ACTUAL PART

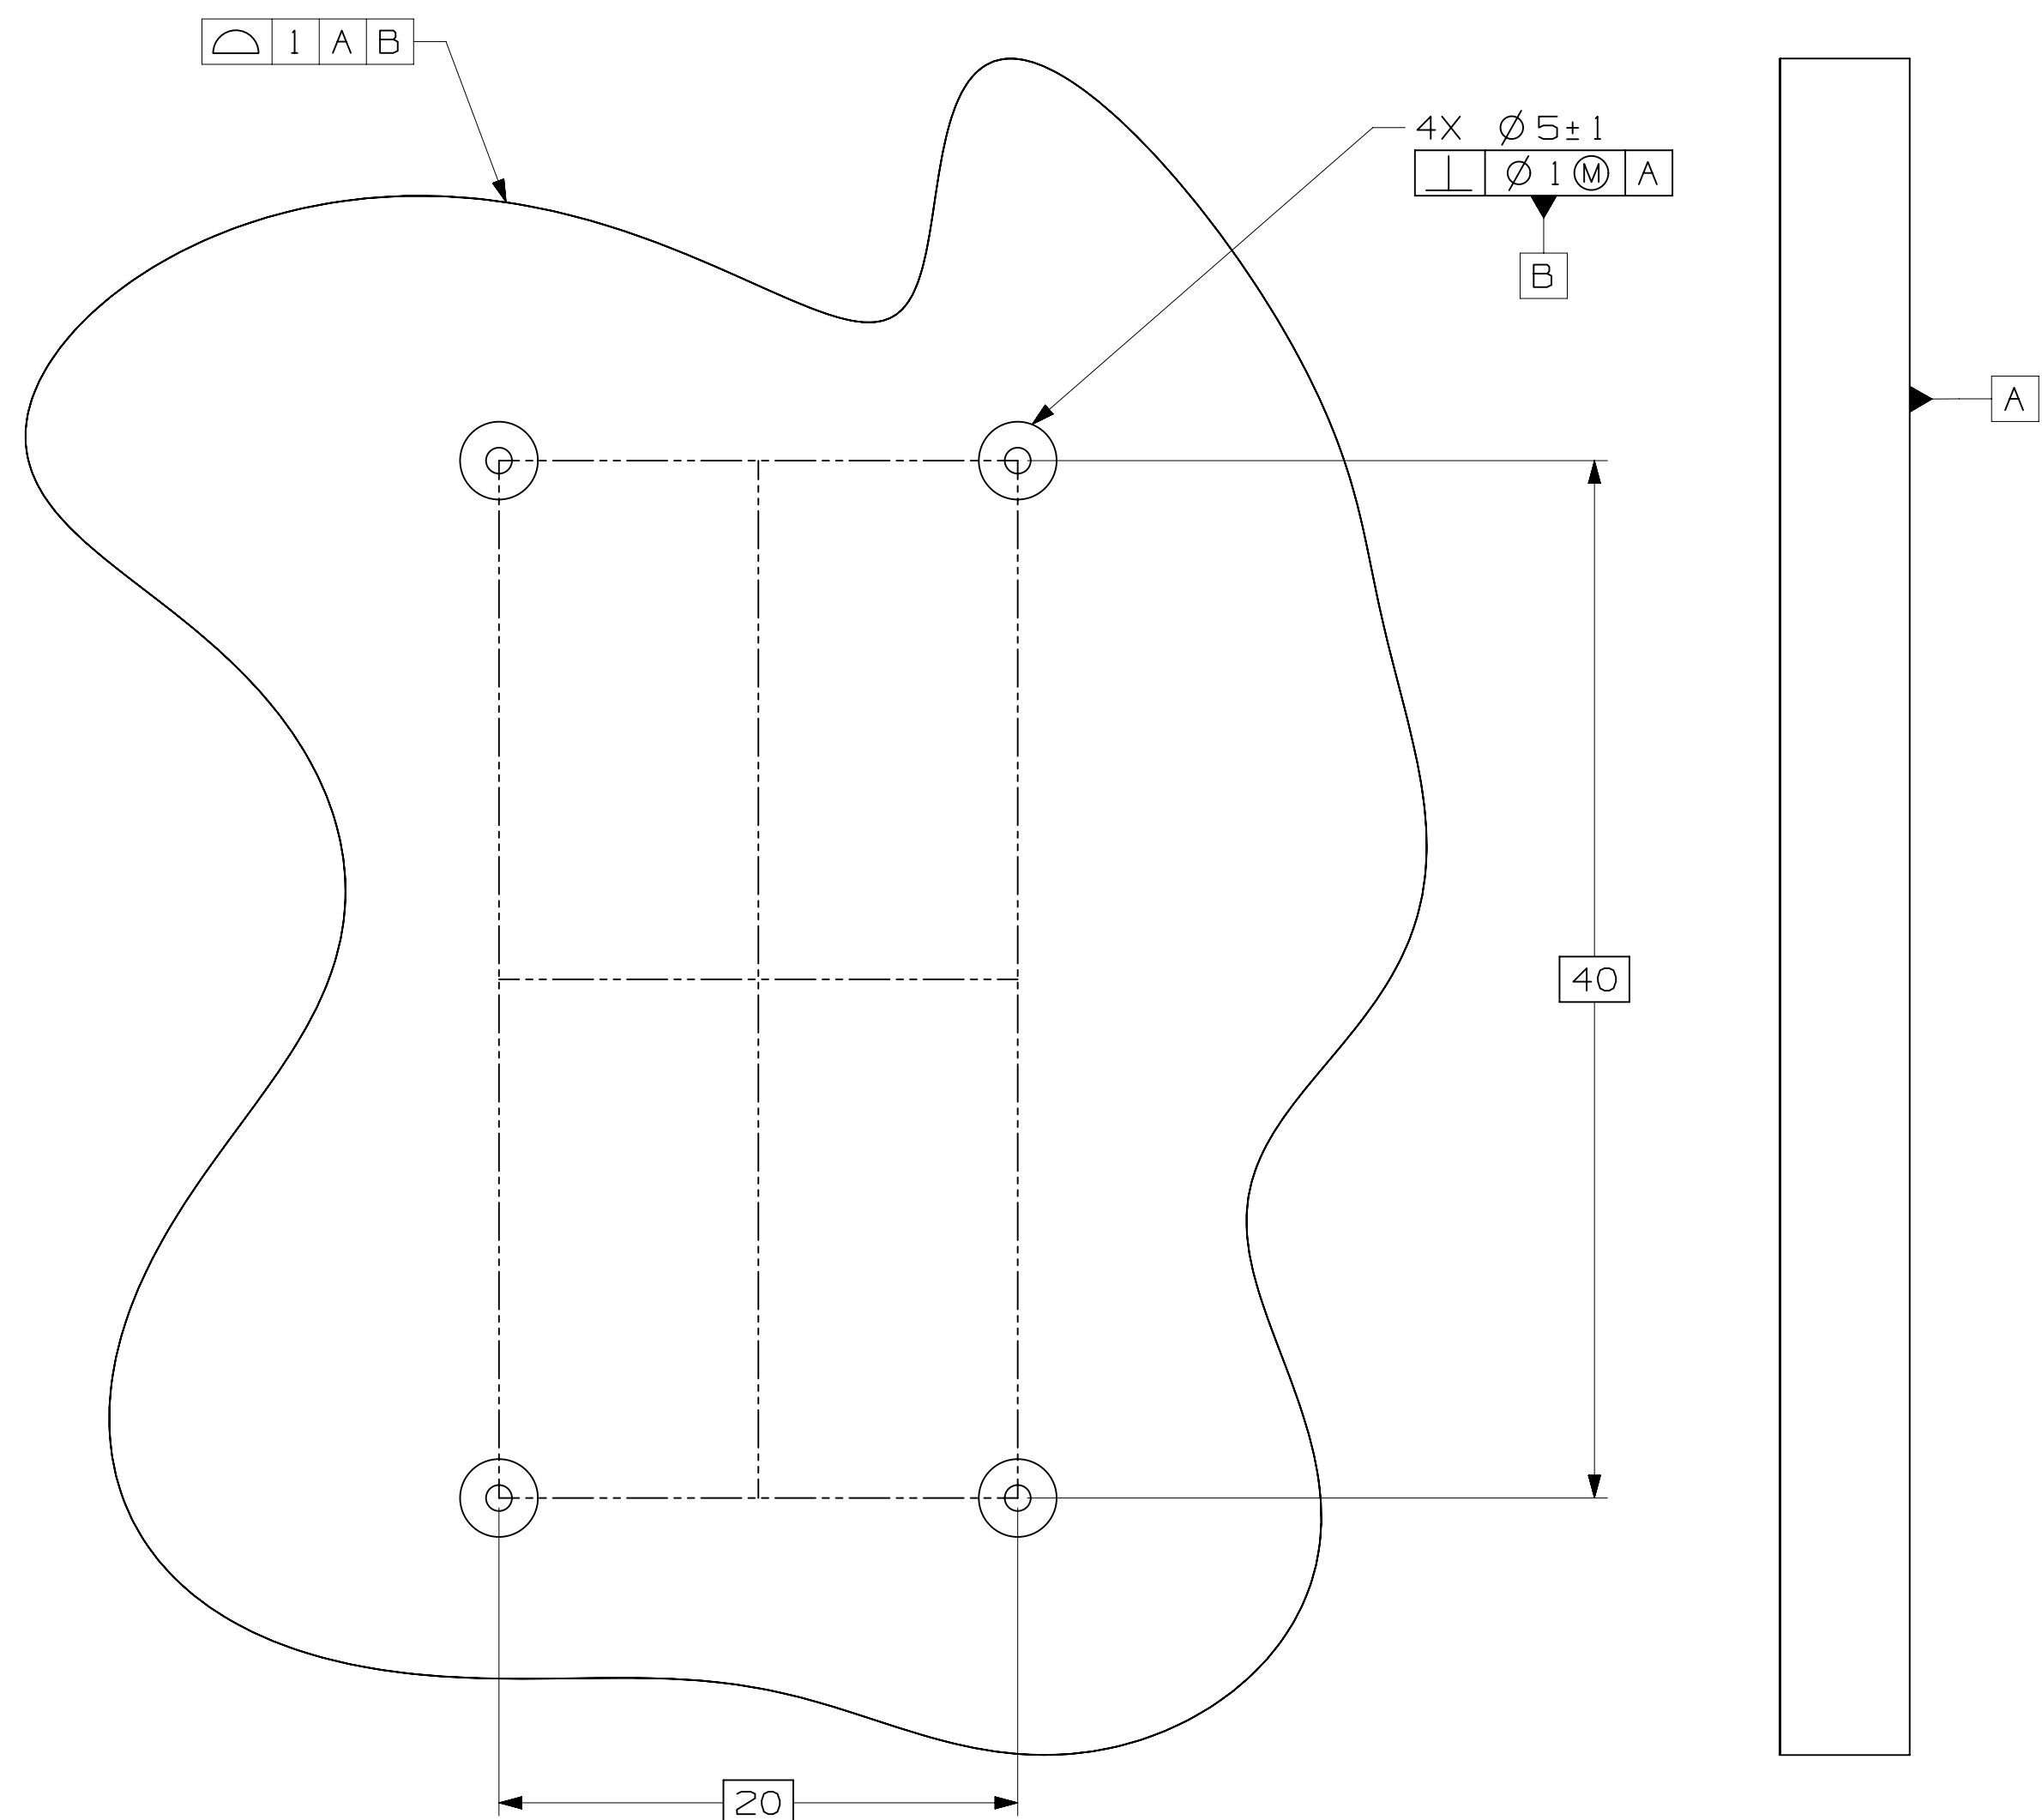
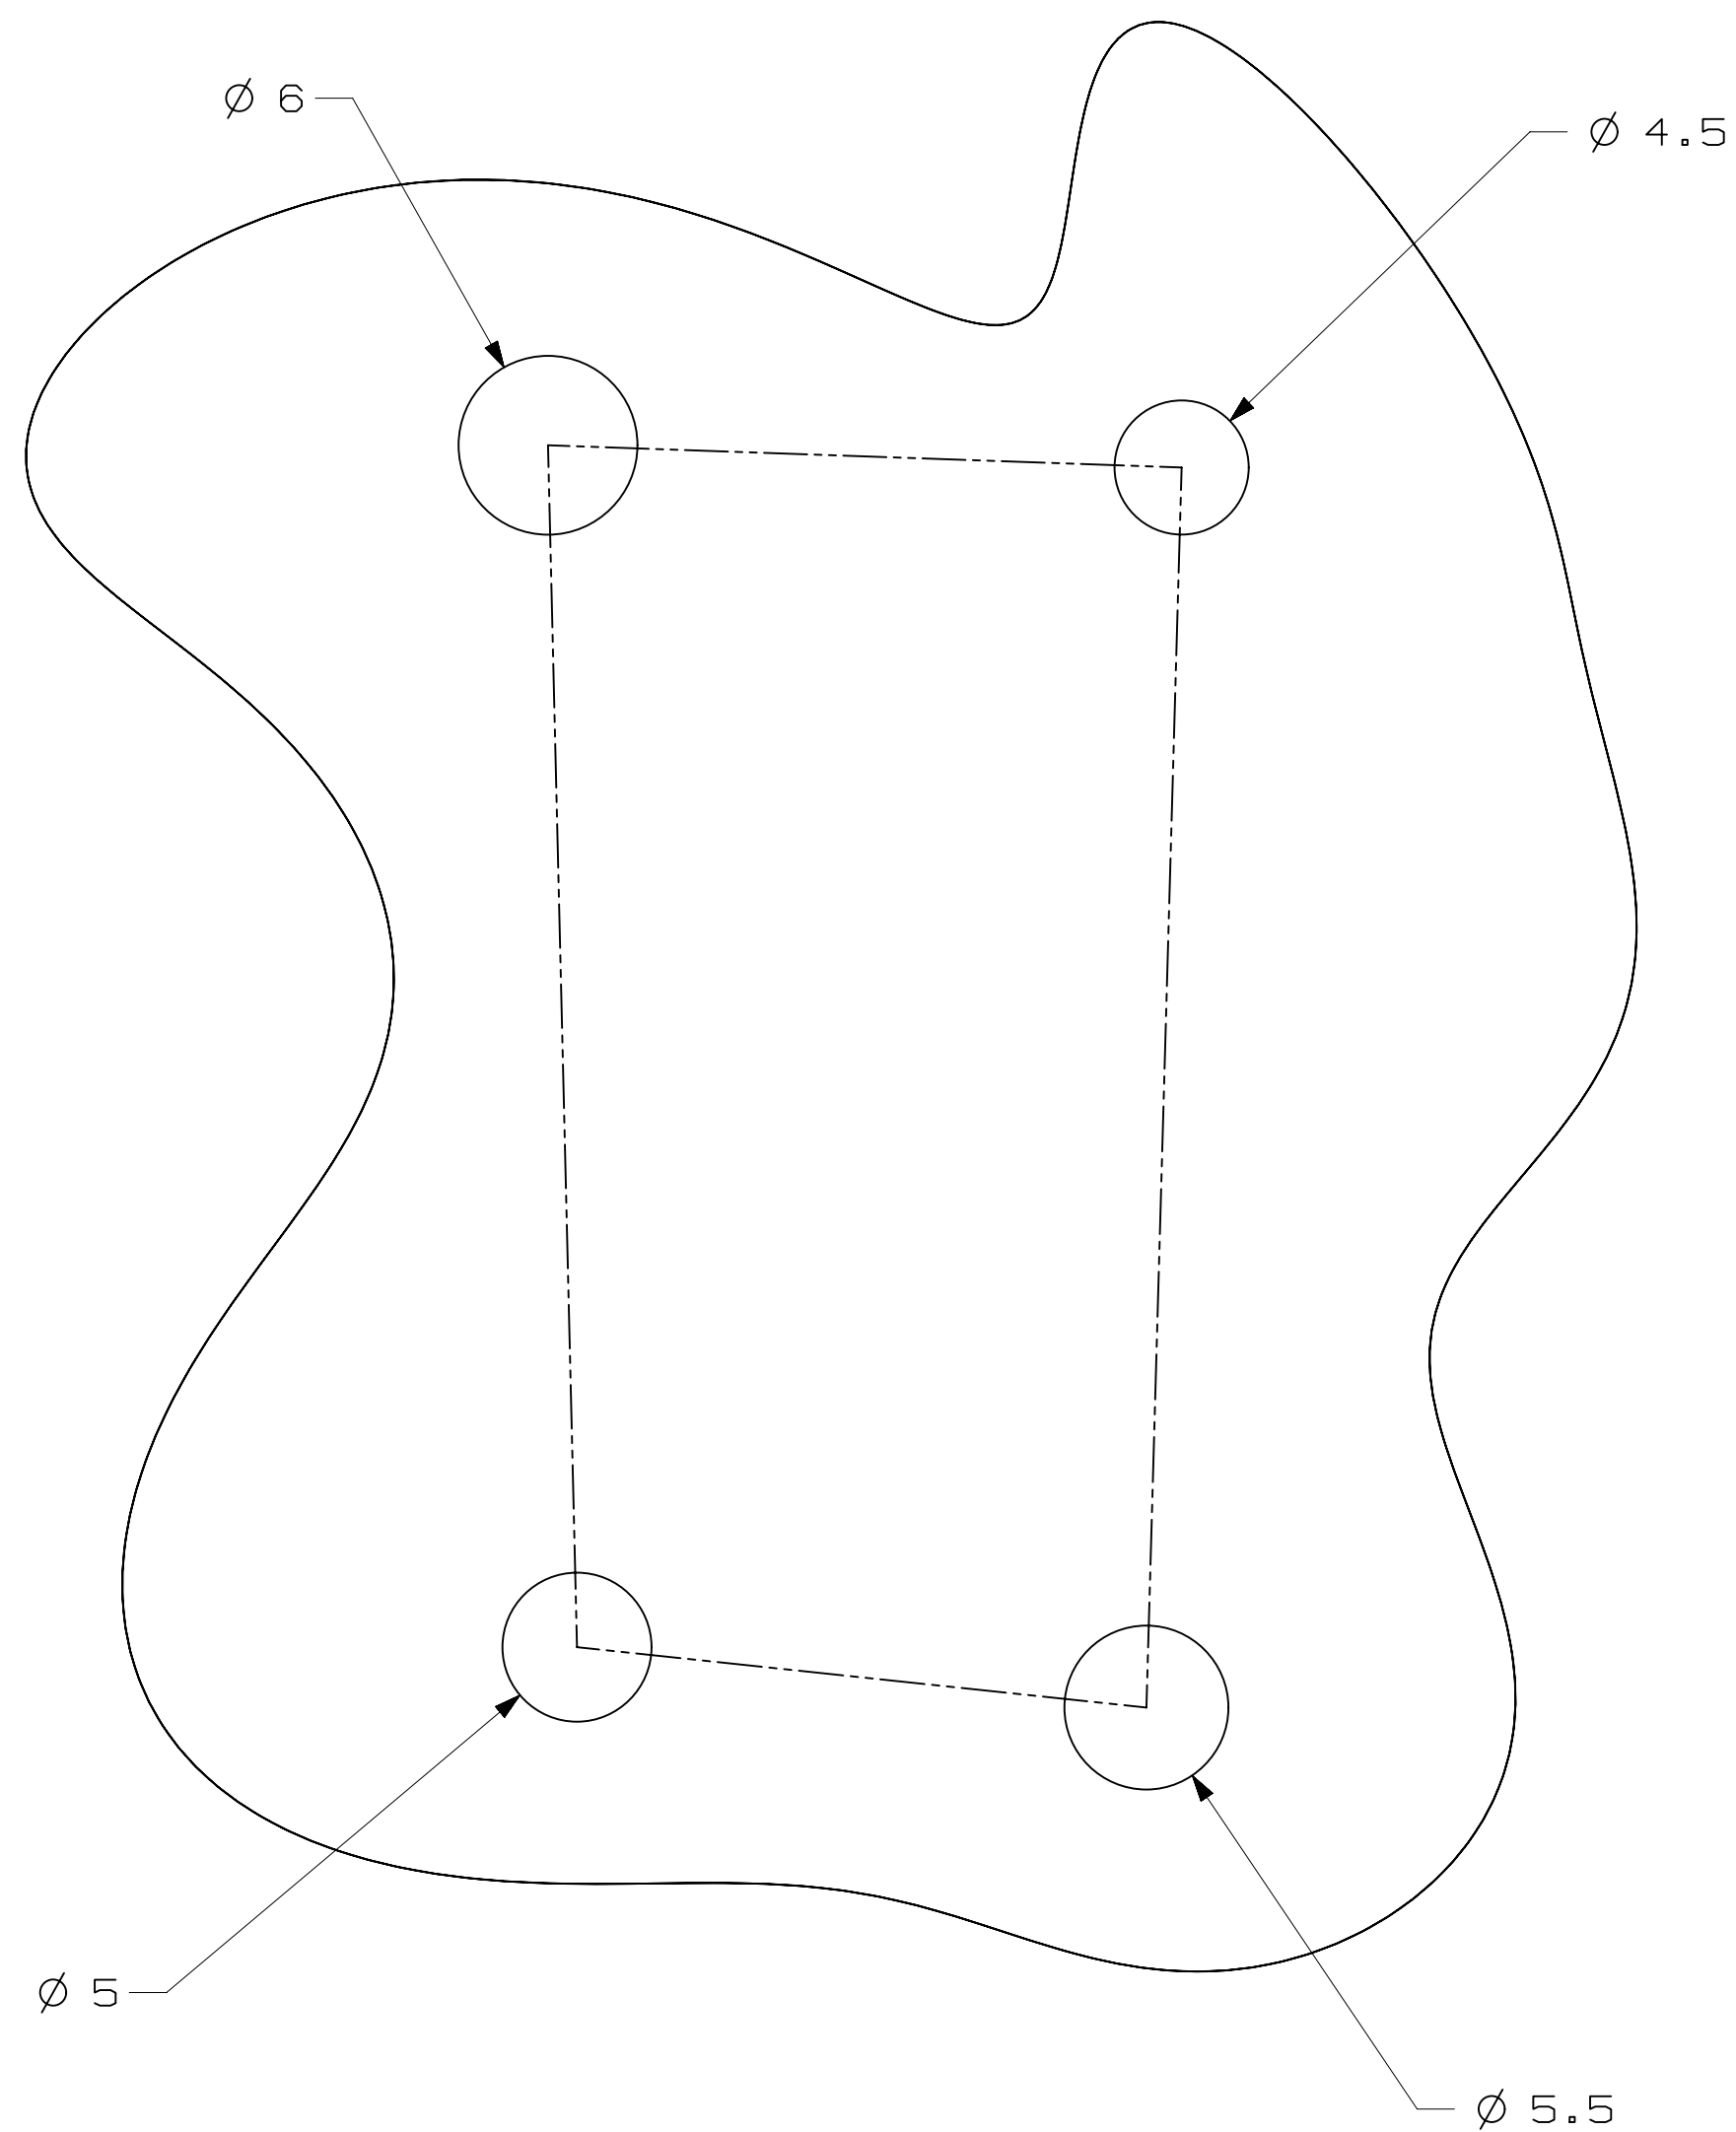
BEFORE THE PROFILE TOLERANCE IS VERIFIED,  
HOW IS THE ACTUAL PART "PATTERN CENTER"  
DETERMINED TO SETUP FOR CMM ?

MODEL WITH OVERLAY  
OF ACTUAL PART

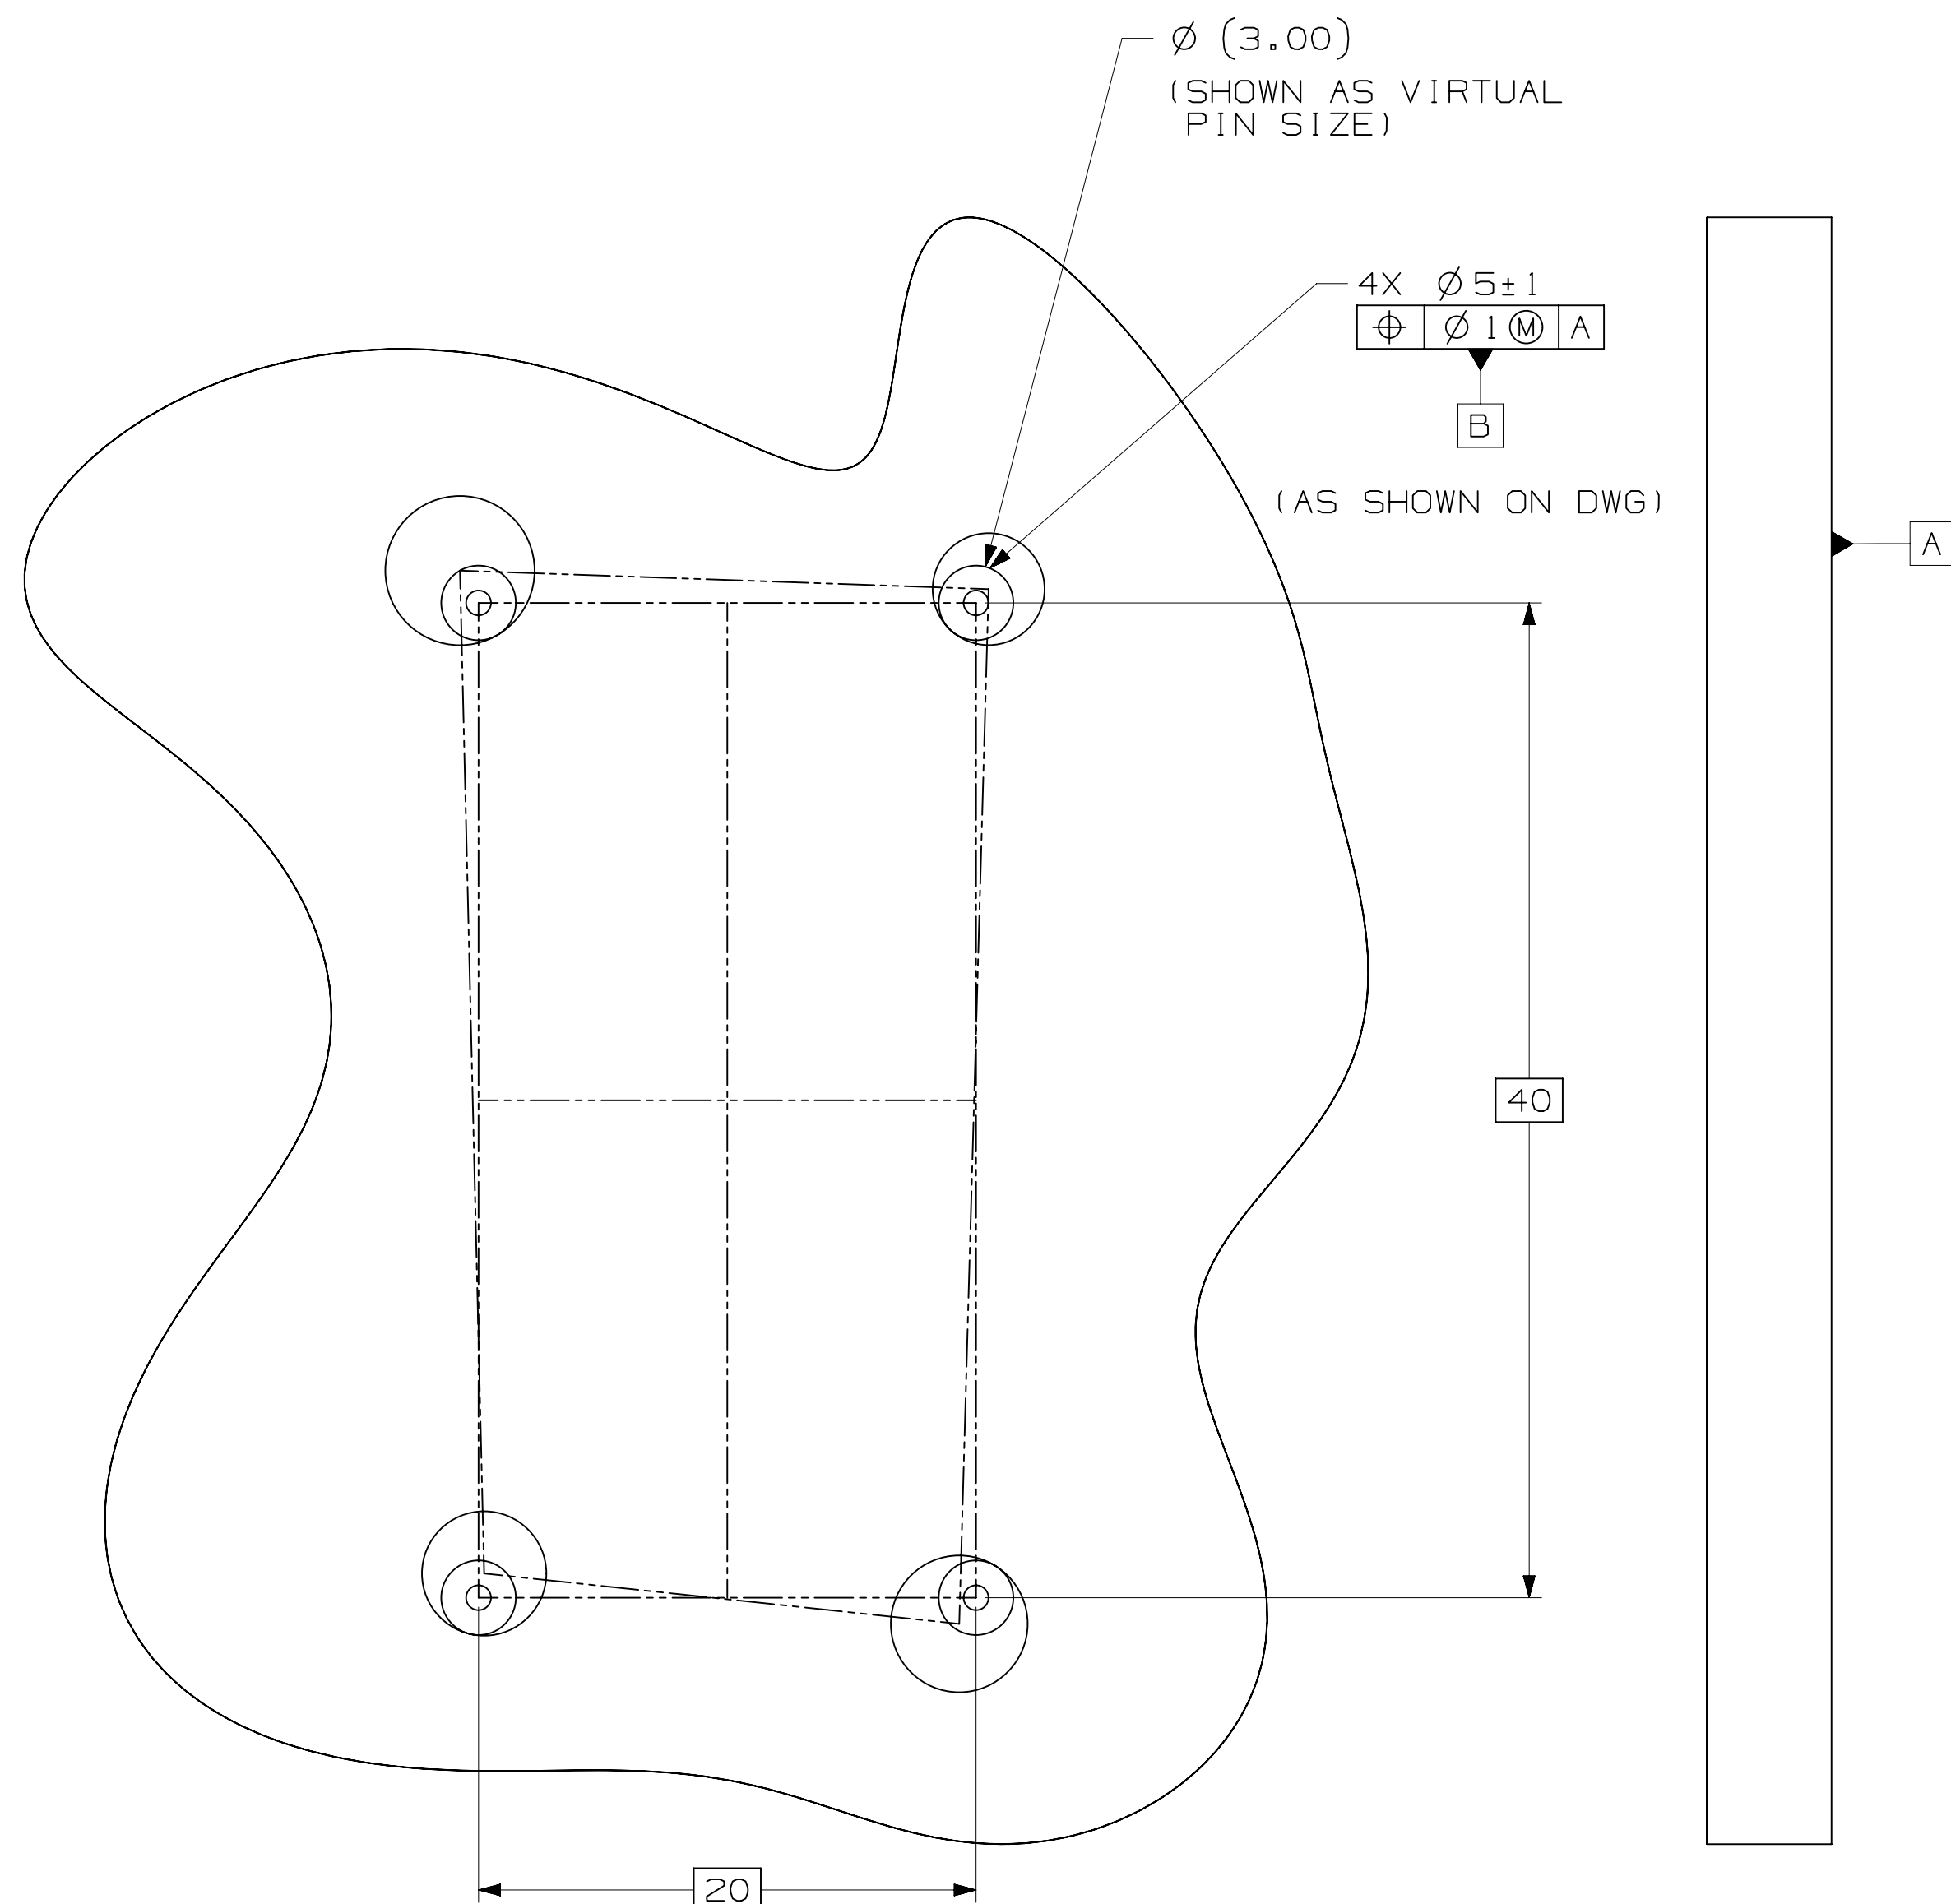
BEFORE THE PROFILE TOLERANCE IS VERIFIED,  
HOW IS THE ACTUAL PART "PATTERN CENTER"  
DETERMINED TO SETUP FOR CMM ?
